RECEIPT DATE: 5/24/23 **ONSITE SEWAGE DISPOSAL SYSTEM** P 574142

PROPERTY ADDRESS: 14005 Clarksville Pike

**SEPTIC SYSTEM
 INSTALLATION SITE PLAN
 14005 CLARKSVILLE PIKE**

From: Silvast, Zackary
Sent: Tuesday, September 26, 2023 2:38 PM
To: Luke Groom
Cc: Paul Cavanaugh; Williams, Jeffrey; Wolf, Kevin; Page, Shepsura; Bernard, Dana
Subject: regarding 14005 Clarkesville Pike OSDS plan revision comments.
Attachments: 14005 Clarkesville Pike specs (most recent).pdf

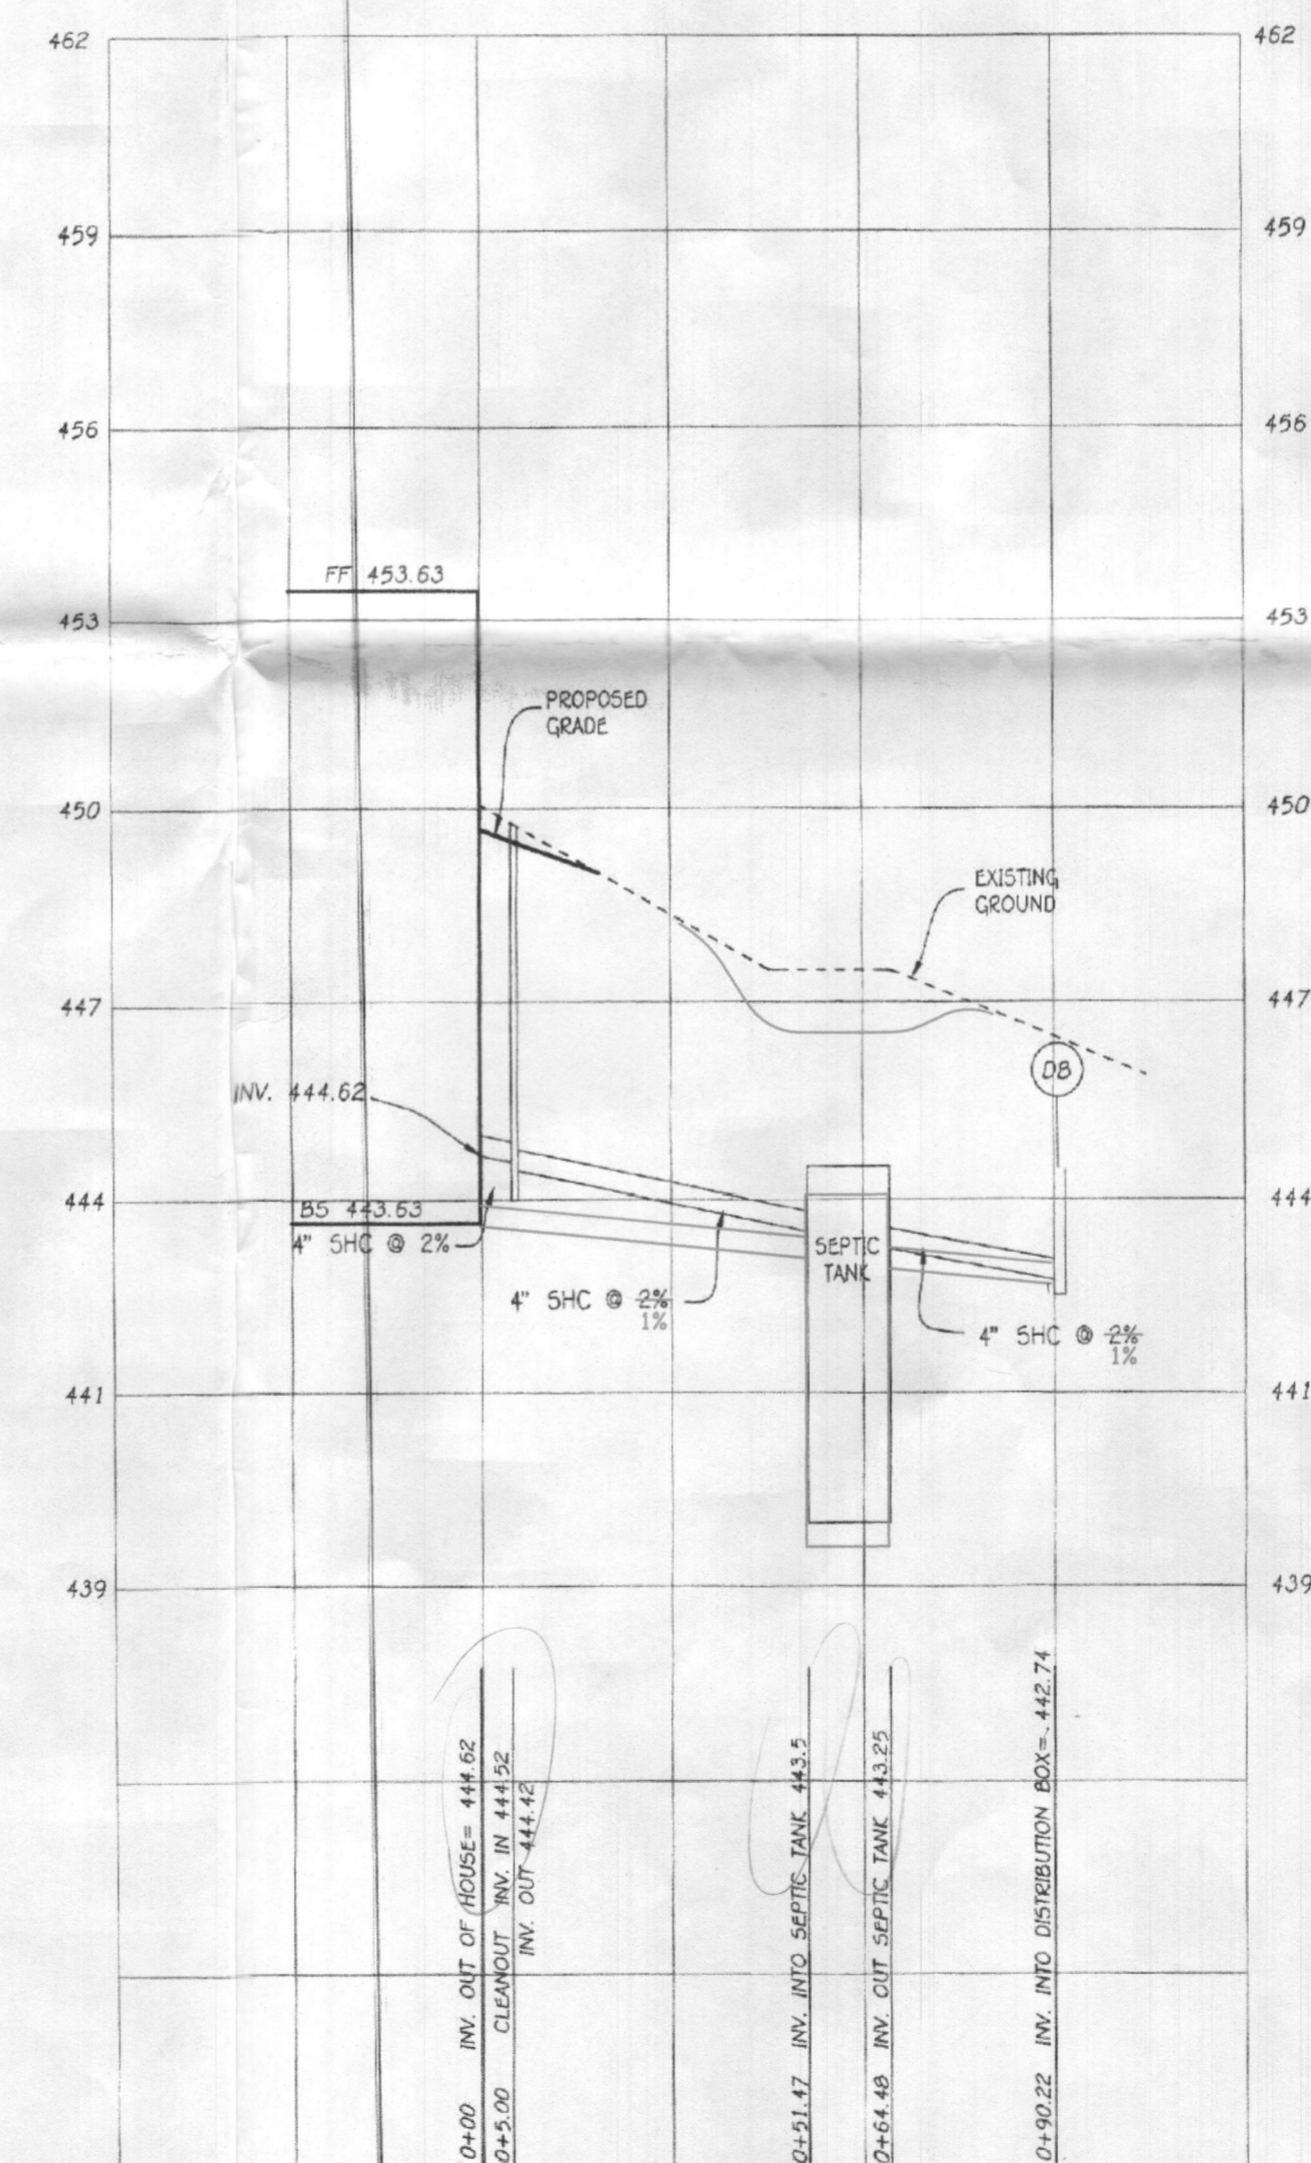
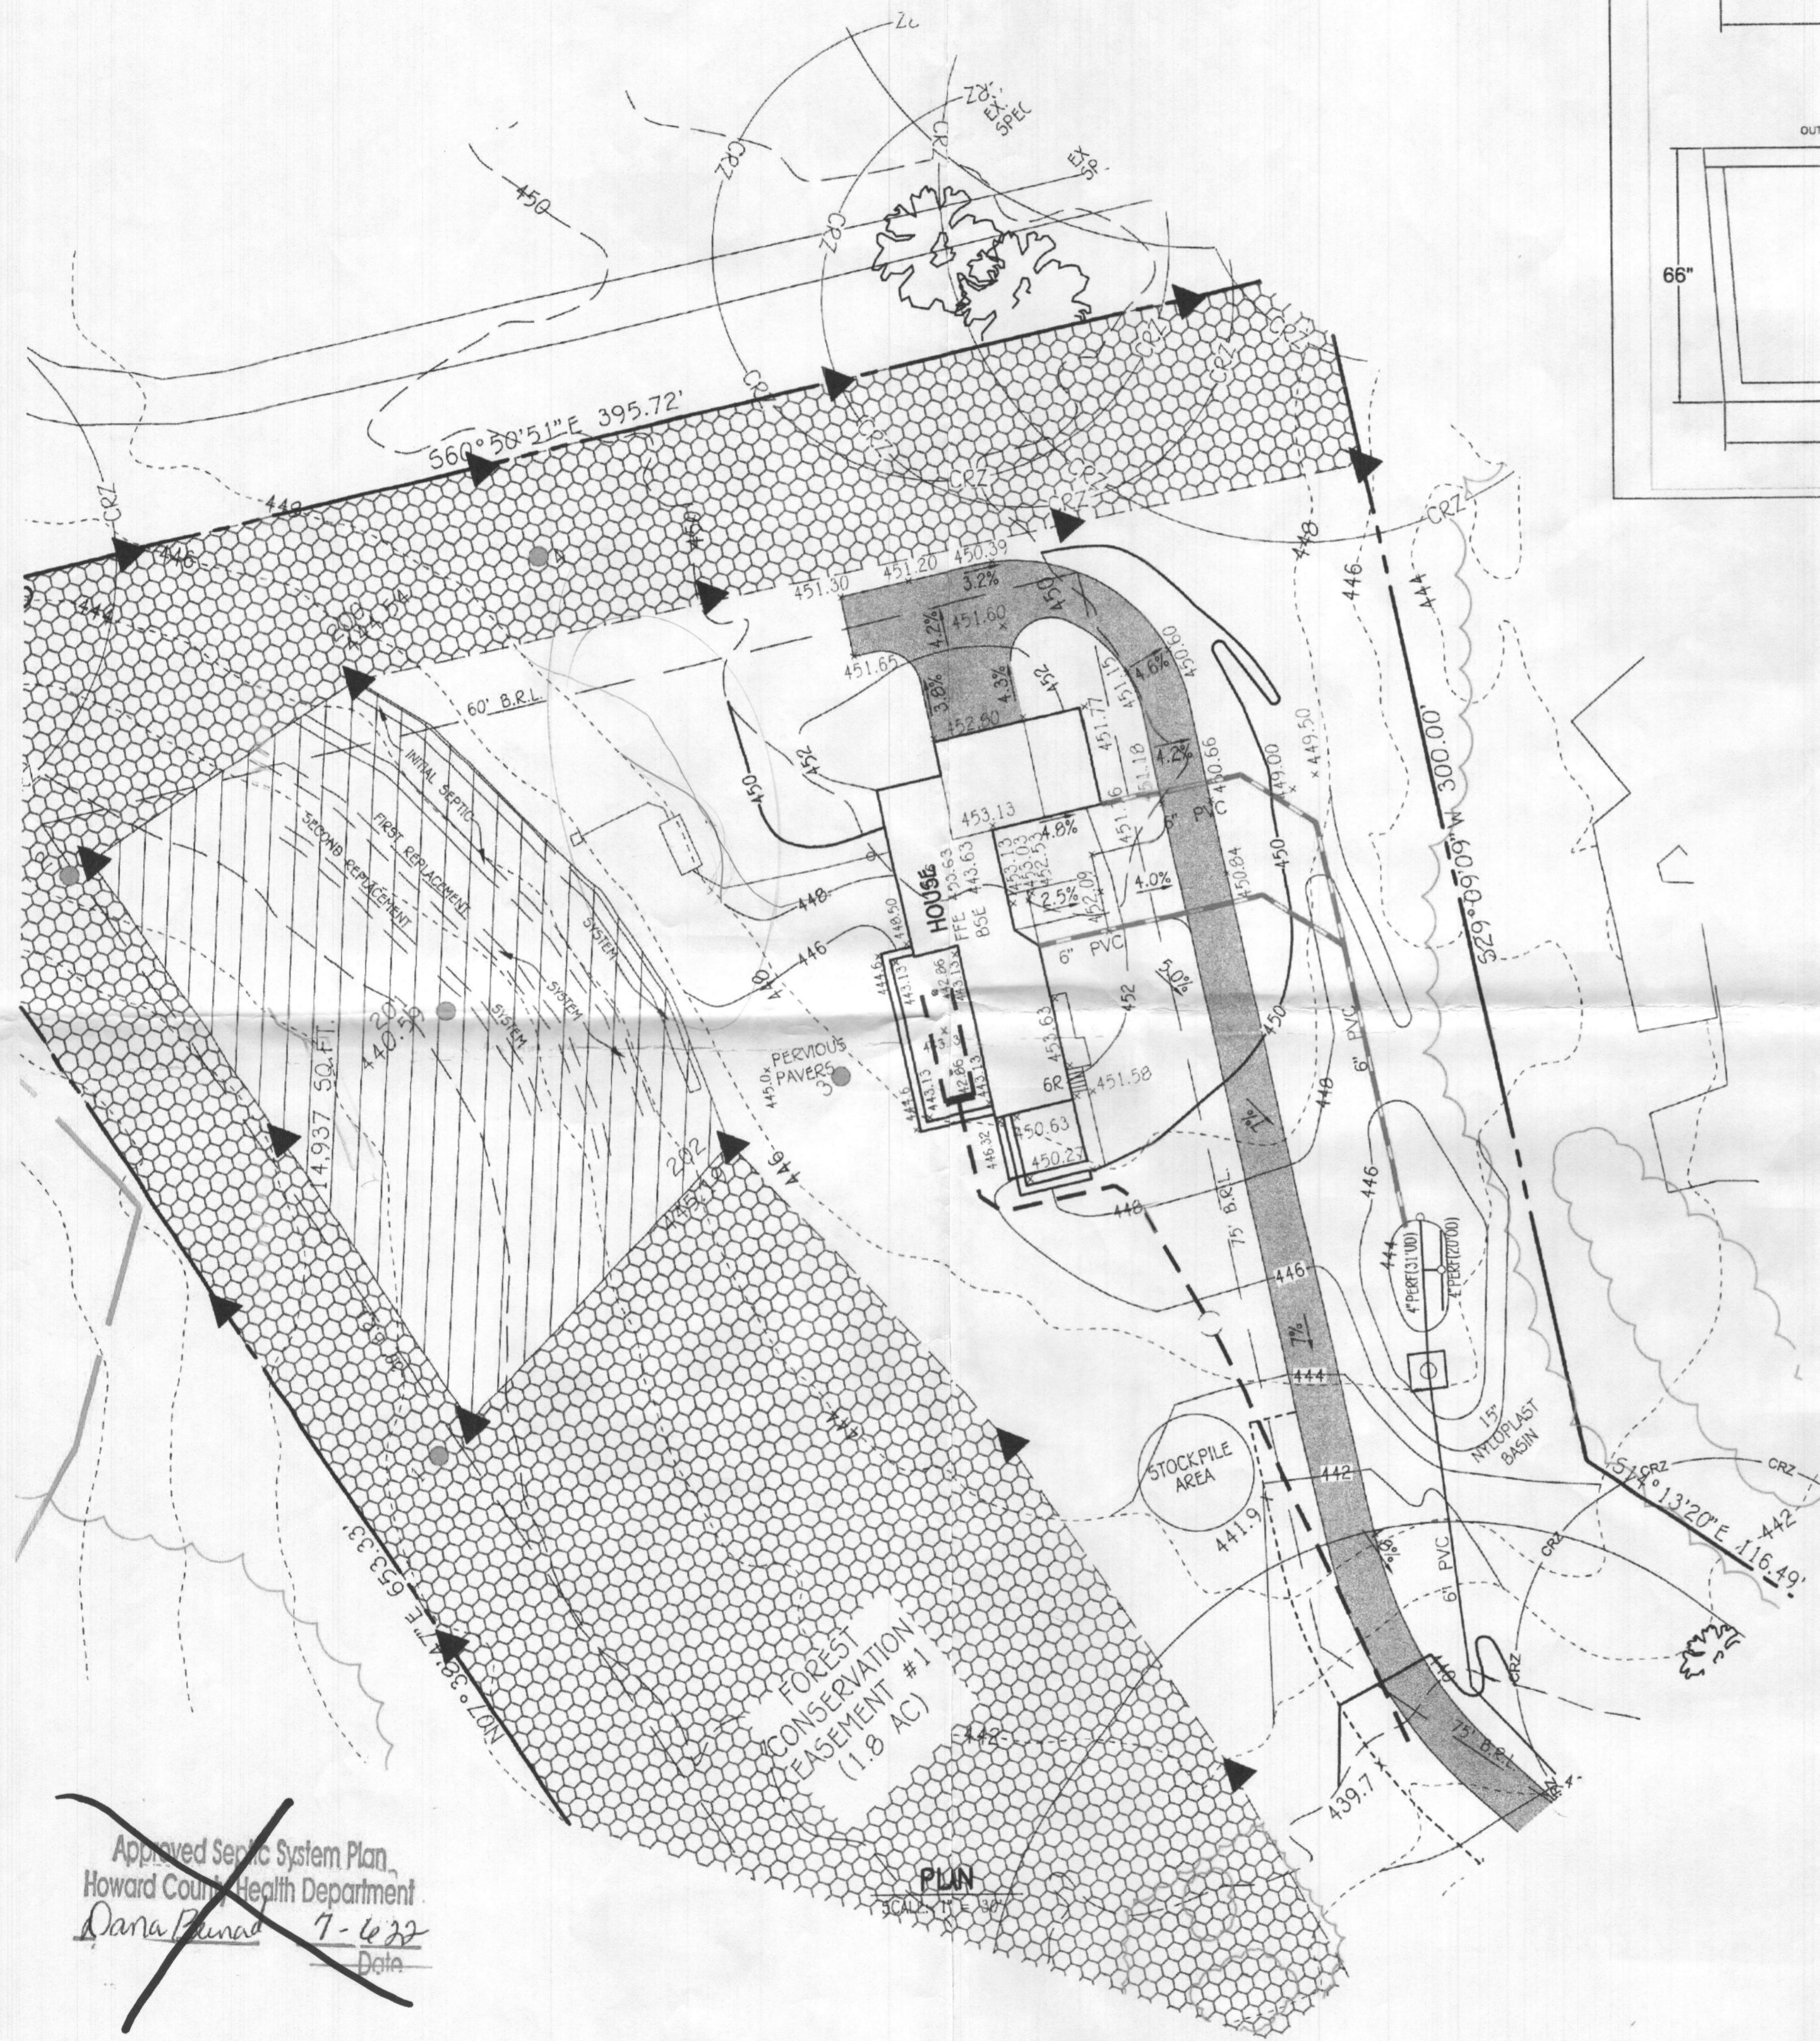
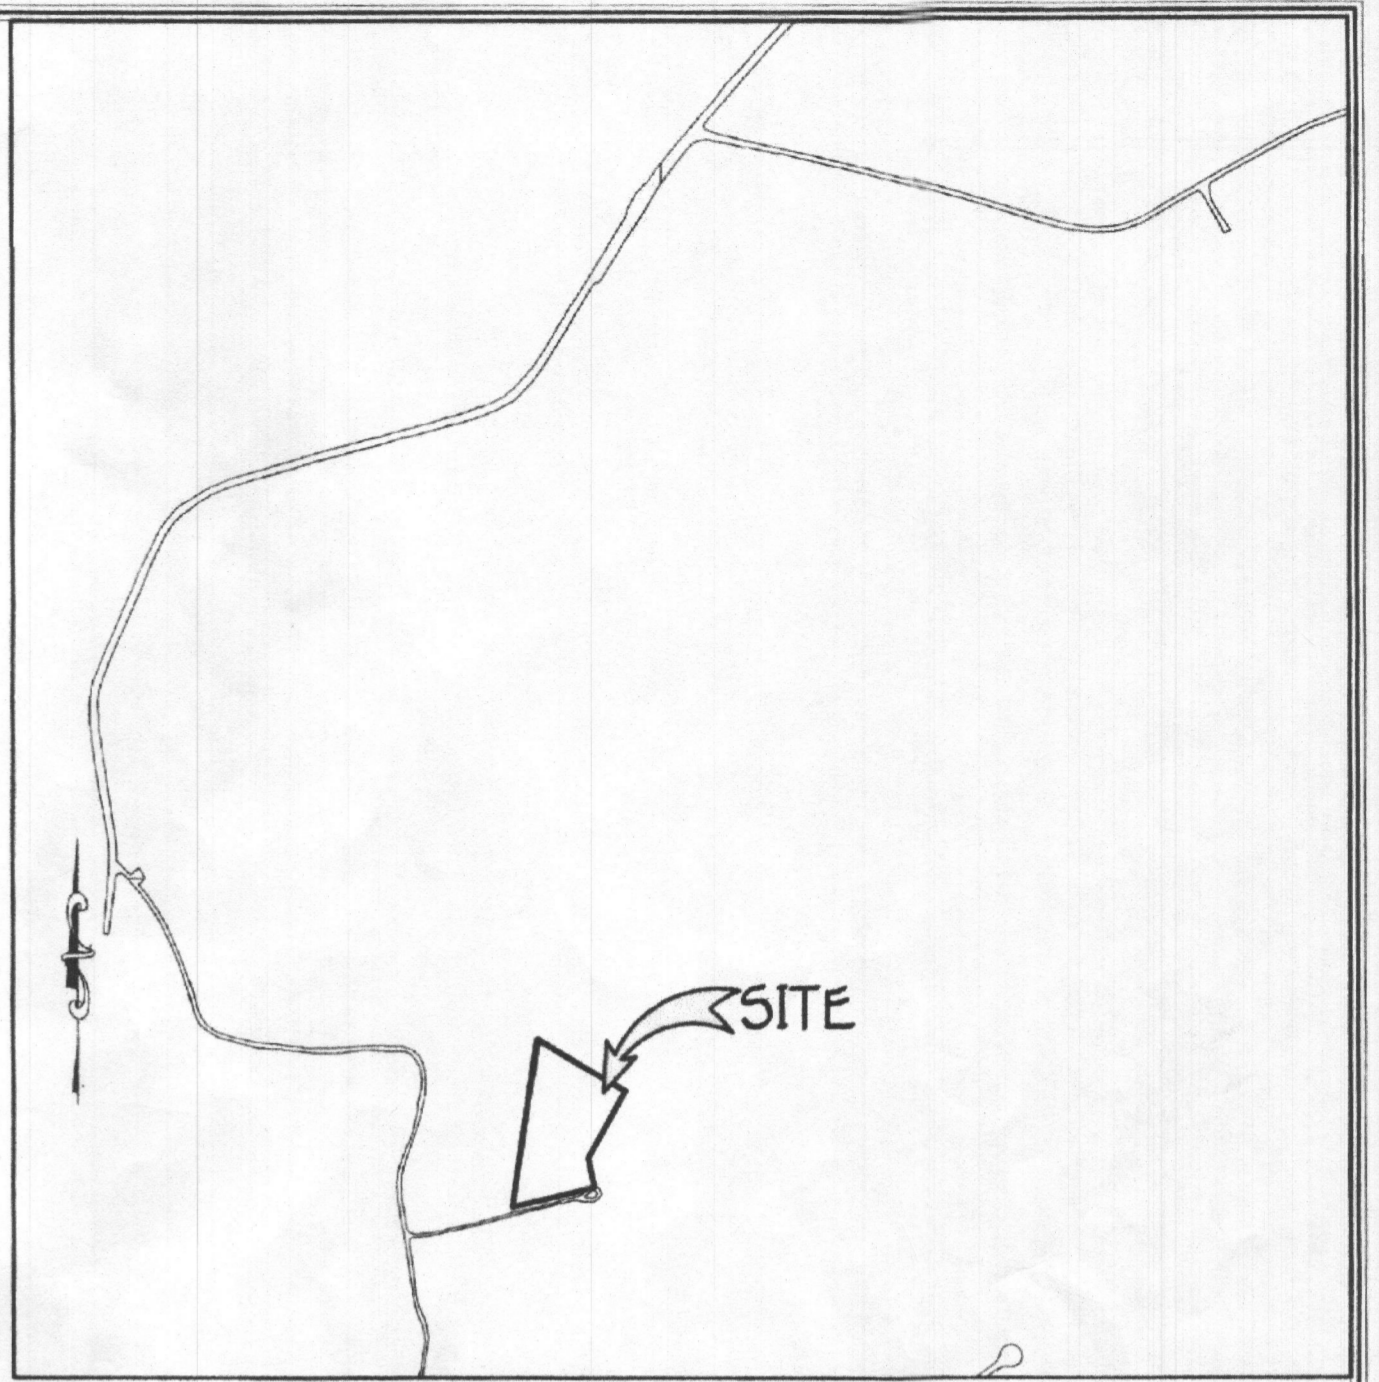
1. **This is no longer a redline submittal. We are requesting a whole new plan with three fresh copies for signature.**
2. **The septic profile detail DID NOT update all the necessary elevation changes with the tank and the invert pipe coming out of the house.**

3. **The redline grading should be flattened out further across contour line 448.**
 - a. **We do not want the tank in that large of a created depression and square in the middle of it.**

- b. **May want to slide the tank downhill closer to the SDA. (might provide better than barely one percent fall from invert)**
4. **The trench data by the initial trench detail is incorrect showing a 6' invert.**

5. **The trench detail itself is incorrect showing the invert going in at 2'.**
 - a. **We need this number deeper than the distribution box, obviously.**

6. **Both the 1st and 2nd replacement systems need to be created around a 0.8 perc rate like the initial system.**
 - a. **The most recent spec sheet was created in 2021 by Jeff Williams which specifies these rates and effective areas. (see attached)**

- b. **PLEASE DOUBLE CHECK ALL CALCULATIONS.**
